UNITED STATES PATENT AND TRADEMARK OFFICE

APPLICATION NO.	FILING DATE	FIRST NAMED INVENTOR	ATTORNEY DOCKET NO.	CONFIRMATION NO.
10/070,467	07/11/2002	Martin John Charles Offa-Jones	THOM-0020	4678

Office Action Summary

DETAILED ACTION

FIG. 1

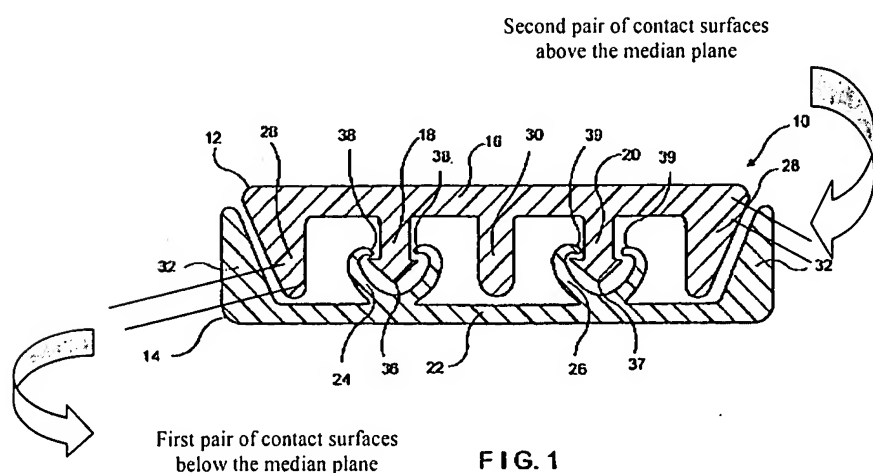
Malin (figure 1) teaches a reclosable fastener for bags, comprising a first element 12 comprising a first elongate body portion 16, at least one first upstanding elongate profiled member 18, 20 extending away from the first body portion, a first upstanding post comprising a wedge-shaped member 28 at a first lateral margin of the first body portion, and a first heel comprising an identically configured wedge-shaped member 28 at a second lateral margin of the first body portion; a second element 14 comprising a second elongate body portion 22, at least one second upstanding elongate profiled member 24, 26 extending away from the second body portion, a second upstanding post comprising a wedge-shaped member 32 at a first lateral margin of the second body portion, and a second heel comprising an identically configured wedge-shaped member 32 at a second lateral margin of the second body portion; wherein the first and second profiled members are releasably engagable when the first and second elements are pressed together with the first and second profiled members facing each other in order to produce

an engaged condition of the first and second elements; and wherein, in the engaged condition, both the first post and the second heel, and the second post and the first heel, are aligned and are arranged to contact each other at respective complementarily angled contact surfaces thereof to form a configuration which provides resistance to compression forces exerted on the first and second elements in their engaged condition thereby substantially preventing distortion of the first and second profiled members under application of a load urging the first and second elements together when in their engaged condition (col. 4, lines 36-61). Pairs of contact surfaces can easily be chosen so as to lie to respective opposite sides of a median plane of separation lying between the first and second body portions, the contact surfaces being angled relative to the median plane and offset therefrom in respective opposite directions perpendicular thereto. There is nothing in the claim language precluding such a labeling.

The high compression members function in the following manner. As one or both of the interlocked male and female profiles 12, 14 are sealed to thermoplastic film, such as by seal bars, the profiles are compressed together. This compression causes the opposing wedge-shaped high compression members 28, 32 on the male and female profiles 12, 14 to contact each other and the central high compression member 30 of the male profile to contact an inner surface 34 of the female profile base 22. The lengths of the high compression members are such that said contacts occur before the extremities 36, 37 of the male interlocking members 18, 20 contact the female profile 14, or the extremities 38, 39 of the female interlocking members 24, 26 contact the male profile 12, and thereby damage or distort the interlocking members. In addition, the high compression members are much thicker than the male and female interlocking members, thereby ensuring that the high compression members themselves do not distort during sealing or become sealed to the opposing profile.

In this manner the high compression members prevent distortion and crushing of the interlocking members and enable the profiles to be sealed to thermoplastic film across the widths of their bases. In the absence of the high compression members the interlocking members would be distorted and/or crushed by the heater bars, rendering the zipper strip unusable.

Applicant's arguments accompanying the last response have been fully considered but they are not persuasive. Applicant argues that with respect to figure 1 of Malin that applicant's last amendment avoids Malin, but the argument is not persuasive.

There is no doubt that the angled contact surfaces of the marginal high compression members 28 and 32 of the respective fastener parts lie to both sides of the median plane, but there is nothing in the claim construction that prohibits this because portions of the angled contact surfaces are clearly offset to opposite sides of the median plane. Applicant has chosen to utilize the open-ended language "comprising" and this language fails to prohibit added structure such as that shown by Malin. Applicant has written claim 16 to indicate that while contact "at least" takes place at the locations indicated by amendment to lines 17 and 22, it is inferred that contact can take place at other locations, too. This is the basis of the application of Malin in the past office action and in this office action. While applicant has inserted the word "entirely" in line 32, this only describes the contact surfaces identified above in connection with Malin and still allows for the contact in other areas as applicant indicates by using the language "at least" in lines 17 and 22.

Applicant further argues that "post" and "heel" are structurally distinct from each other. However, these terms are broad and there are no features or dimensions claimed that would distinguish one from the other. The angled surface toward the end of a post contacts an angled surface adjacent the opposite base considered to be a heel and not only the heel, but the end of the heel adjacent the base. While obviously, there are features and dimensions disclosed that
